Title - Sujet CCGS George R. Pearkes - VLE	
Solicitation No. - N° de l'invitation F7049-200083/A	Amendment No. - N° modif. 016
Client Reference No. - N° de référence du client F7049-200083	Date 2022-06-06
GETS Reference No. - N° de référence de SEAG PW-\$\$MD-029-28531	
File No. - N° de dossier 029md.F7049-200083	CCC No./N° CCC - FMS No./N° VME
Solicitation Closes - L'invitation prend fin at - à 02:00 PM Eastern Daylight Saving Time EDT on - le 2022-07-07 Heure Avancée de l'Est HAE	
F.O.B. - F.A.B. Plant-Usine: <input type="checkbox"/> Destination: <input type="checkbox"/> Other-Autre: <input type="checkbox"/>	
Address Enquiries to: - Adresser toutes questions à: Jeddi, Loubna	Buyer Id - Id de l'acheteur 029md
Telephone No. - N° de téléphone (873) 45--383 ()	FAX No. - N° de FAX (819) -
Destination - of Goods, Services, and Construction: Destination - des biens, services et construction:

Solicitation Amendment # 016

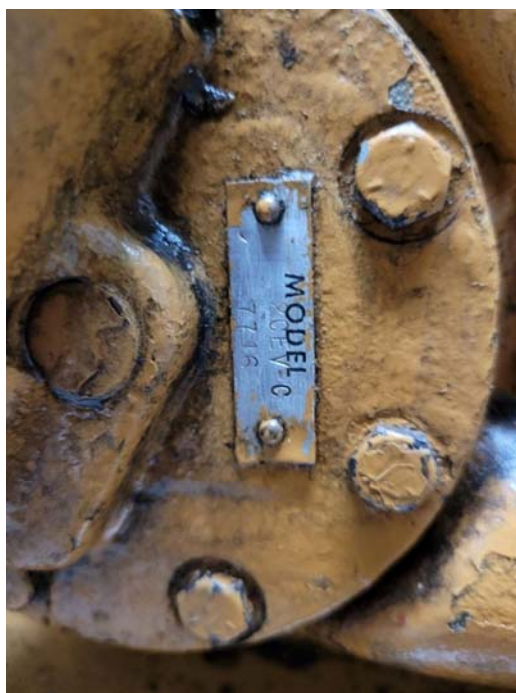
Q#4: Q4-R4 AMD 14 for a 2nd time, at item E3.3.4.8 can you indicate the specification of the pre-lubrication pump to be supplied, model, type, etc. and share the nameplate of the pump existing?

A#4: Delete all Reference to the CSM pre-lube pump from Amendment #14 and Specification E-03 - Section 3.4.7.

The new "Flocs" system and pre-lube pump must be installed by the Contractor to the satisfaction of the CGTA in correlation with the installation of the new C32 new unit. However, these units will be GSM.

The existing pre-lube pump is a tuthill (kim hotstart) pump (model 2CEV-C 7716) unit powered by a 1hp 600v volt Balder Baldor motor. Additional Pictures with requested info are attached below.
